BT12-020b

NTB13-010b

April 16, 2013

2013 PATHFINDER; NOISE DUE TO REAR SPOILER CONTACTING ROOF WHEN OPENING/CLOSING BACK DOOR

Figure 10

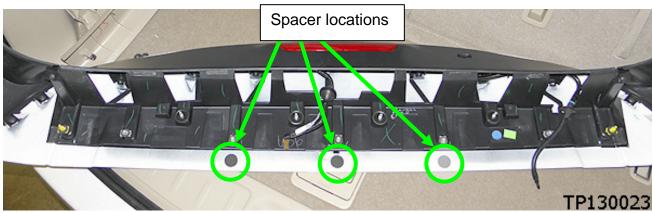
11. Install 3 foam self adhesive spacers to the spoiler as shown in Figure 10.

- Wipe/clean the spoiler surface with an alcohol wipe from the squeak and rattle kit before installing the foam pads.
- Place each foam spacer centered **directly in front of** the 3 center clip locations.

Figure 12

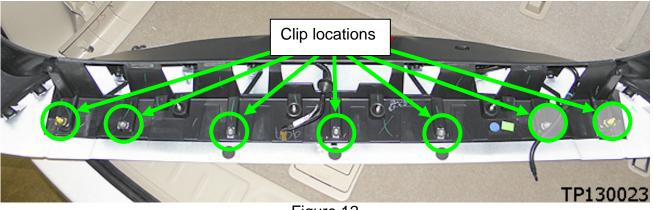
12. Replace all 7 spoiler clips with new ones listed in PARTS INFORMATION.

- 5 grey clips (the center clip and the 2 clips to the right side and 2 to the left side of the center clip).
- 2 yellow clips (one at either end).
